# Work Order ID 119099

Item Name: Crosstube Turning Detail

DRAWING NO. D212-664-241	TITLE CROSSTUBE ASSY (205/212 HI AFT)	REV. D	DART AEROSPACE LTD ENGINEERING ORDER		D.E.O. NO. D212-664-241-D-1	SHEET NO. SHEET 1 OF 2	SCALE NTS
DRAWN	CHECKED	MFG. APPR.	APPROVED	DE APPR.			
DATE 11.04.07	DATE 11.04.11	DATE 11.04.12	DATE 11/04/12	DATE 11.04.12

DRAWING NO. D212-664-241	TITLE CROSSTUBE ASS'Y (205/212 HI AFT)	REV. D	<b>DART AEROSPACE LTD ENGINEERING ORDER</b>		D.E.O. NO. D212-664-241-D-2	SHEET NO. SHEET 1 OF 1	SCALE NTS
DRAWN <i>97</i>	CHECKED <i>A.S.S.</i>	MFG. APPR. <i>8</i>	APPROVED <i>MD</i>		DE APPR. <i>H</i>		
DATE 11.07.15	DATE 11.07.20	DATE 11.07.21	DATE 11.07.21		DATE 11.07.21

D212-664-241/-241B  
ASSEMBLY DETAIL

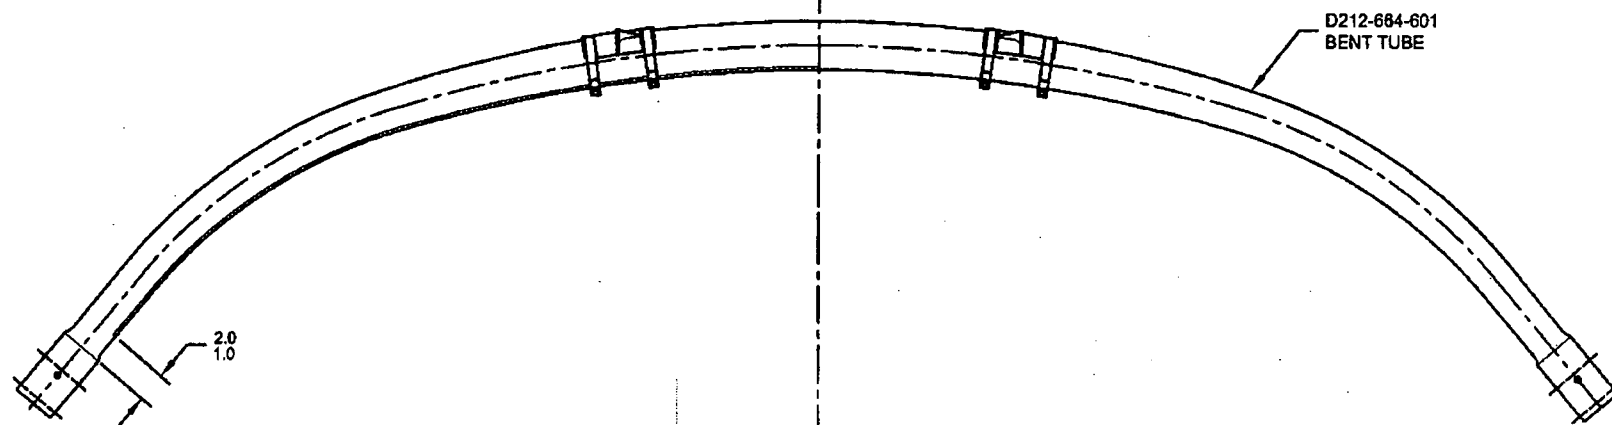
ADD AN INSPECTION WINDOW TO UNDERSIDE OF CROSSTUBE.

NOTES 2 OF SHEET 1 IS AMENDED AS FOLLOWS:

- 2) FINISH: CHEMICAL CONVERSION COAT PER DART QSI 005 4.1  
PRIME INSIDE AND OUTSIDE PER DART QSI 005 4.2  
PAINT OUTSIDE PER DART QSI 005 4.2

- 2) FINISH: CHEMICAL CONVERSION COAT PER DART QSI 005 4.1  
PRIME INSIDE AND OUTSIDE PER DART QSI 005 4.2  
MASK UNDERSIDE OF CROSSTUBE AS SHOWN (HATCHED AREA) AND  
PAINT OUTSIDE PER DART QSI 005 4.2  
REMOVE MASKING AND APPLY CLEAR COAT

MASK AREA PRIOR TO PAINTING,  
REMOVE MASKING AFTER PAINT  
AND APPLY CLEAR COAT
